# UNITED STATES PATENT AND TRADEMARK OFFICE

10/800,080

<b>Office Action Summary</b>	<b>Application No.</b> 10/800,080	<b>Applicant(s)</b> CAMPBELL ET AL.	
	<b>Examiner</b> Tho D. Ta	<b>Art Unit</b> 2833

## **DETAILED ACTION**

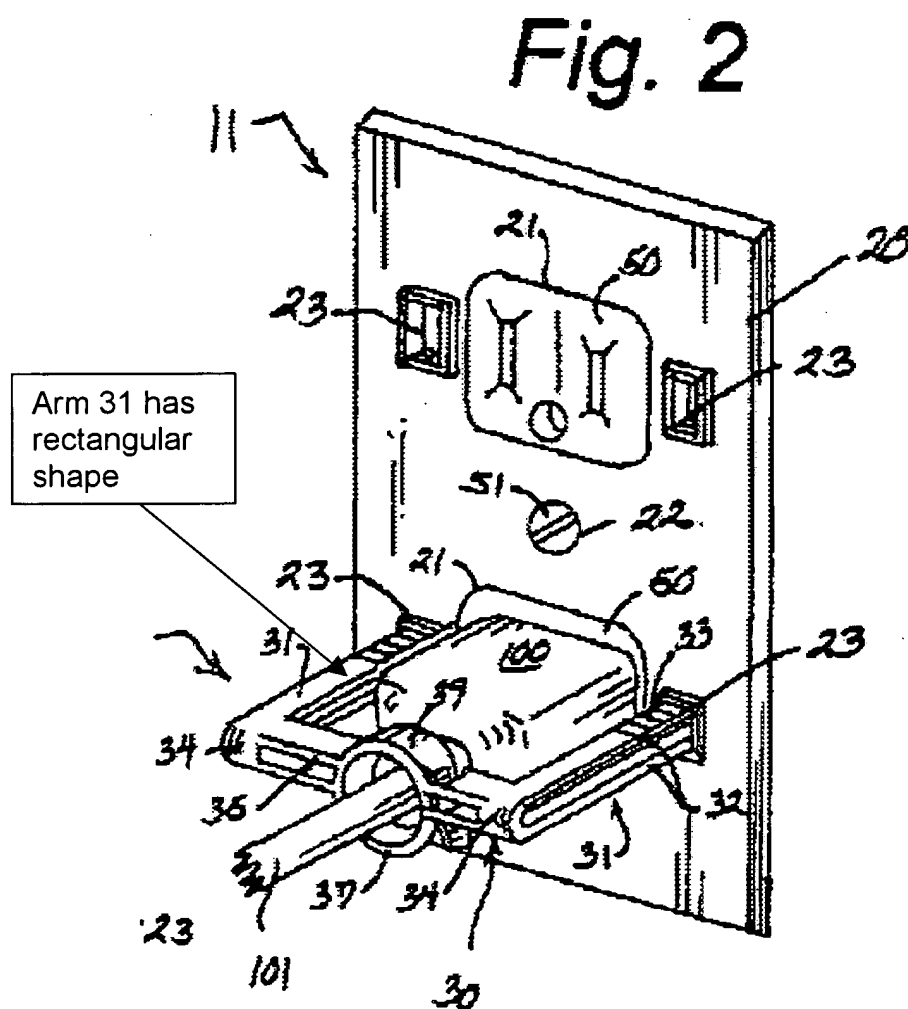
In regard to claim 7, McDevitt, Jr. discloses that the tabs 31 are rectangular (see attached drawing).

FIG. 1

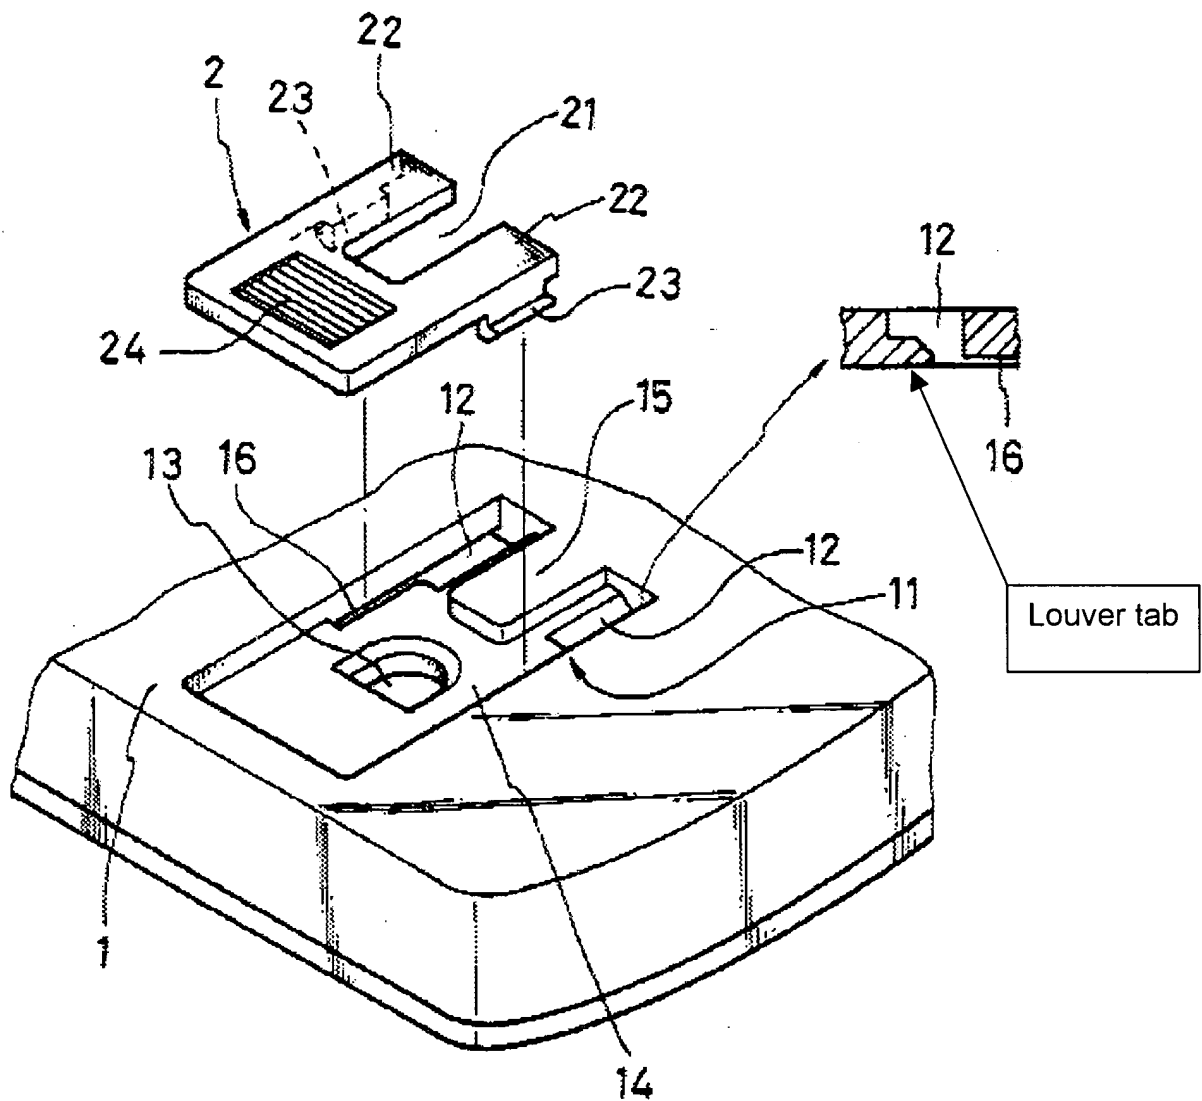
Chou discloses (in attached fig. 1) that the holes 12 in the outlet cover 1 includes a louver tab (see attached drawing) to prevent objects from being placed through the inside of the holes 12.

Therefore, it would have been obvious to one of ordinary skill in the art at the time the invention was made to modify Rust's invention by constructing the hole with a louver as disclosed by Chou in order to prevent foreign debris from entering the hole.
